The Commission has issued the enclosed Amendment No. 25 to License No. DPR-38; Amendment No. 25 to License No. DPR-47; and Amendment No. 22 to License No. DPR-55 for the Oconee Nuclear Station, Units Nos. 1, 2, and 3. The amendments consist of changes to the Technical Specifications and are in response to your requests dated May 7, 1976.

OCONEE NUCLEAR STATION, UNIT 1

Amendment No. 25
License No. DPR-38

ATTACHMENT TO LICENSE AMENDMENTS

OCONEE NUCLEAR STATION
STATION ORGANIZATION CHART
FIGURE 6.1-1

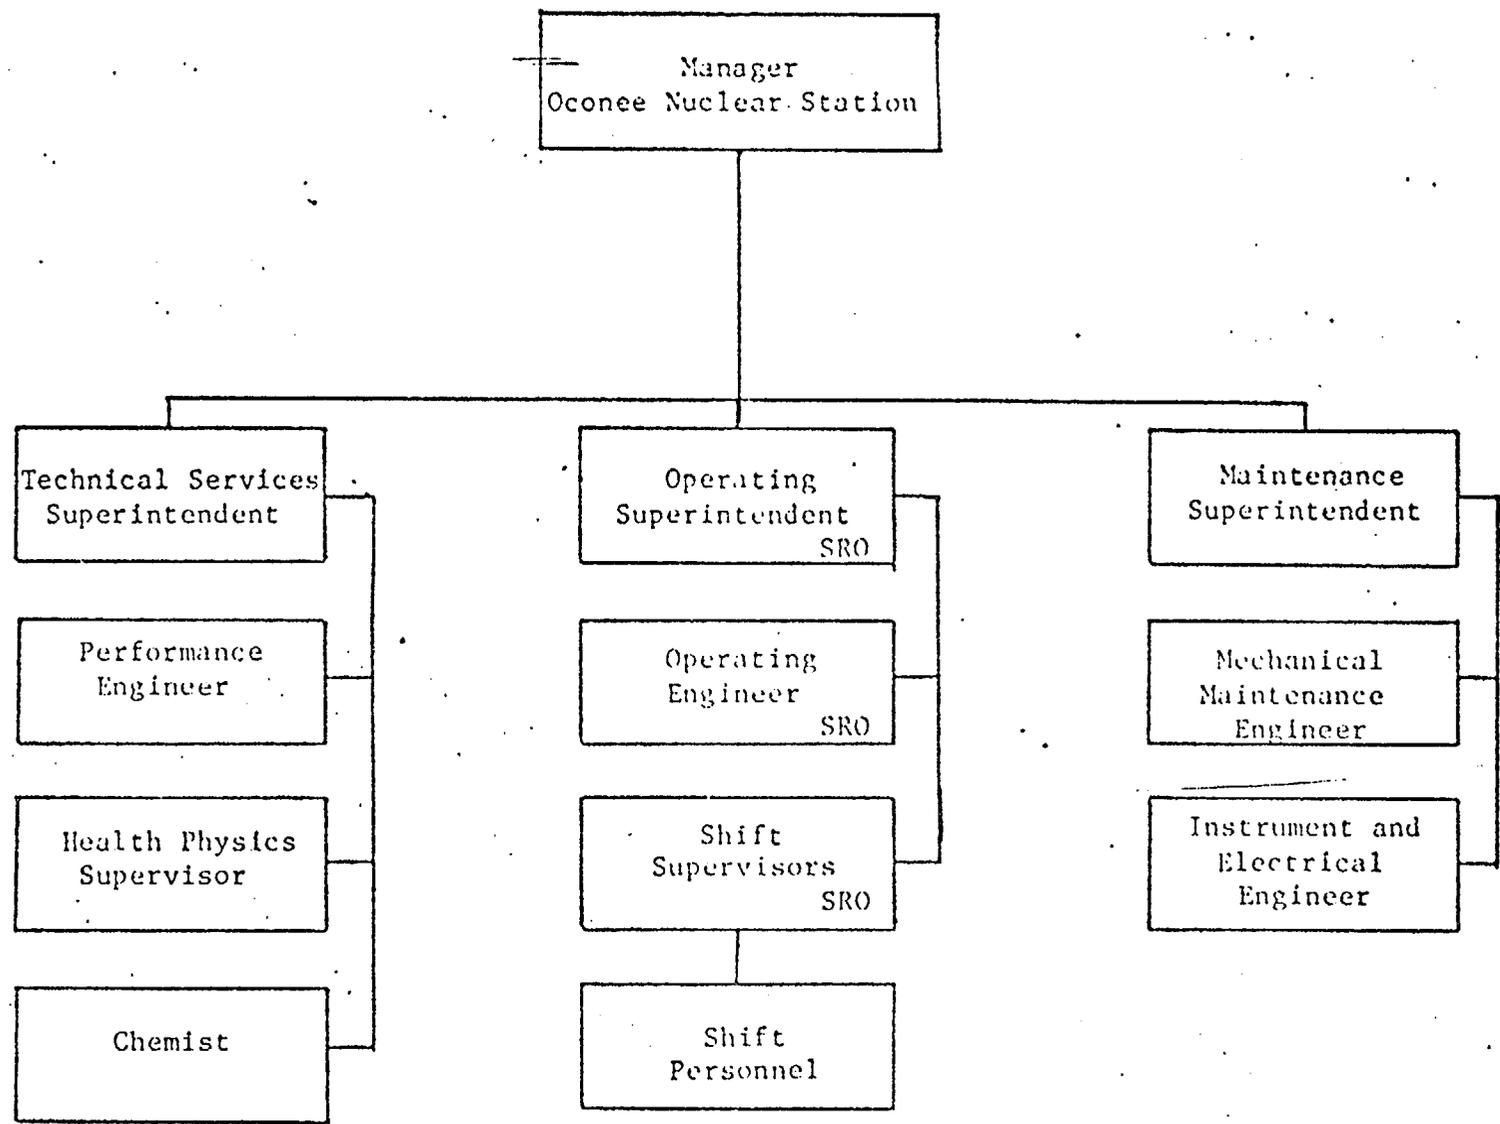
These amendments restructure the Oconee Station Organization for Maintenance by establishing two separate branches for mechanical and electrically-related maintenance. These amendments also revise the provisions in the Technical Specifications to require annual reporting of the nonradiological environmental data.

Remove Figure 6.1-1 (page 6.1-1) and insert revised Figure 6.1-1 (page 6.1-7)
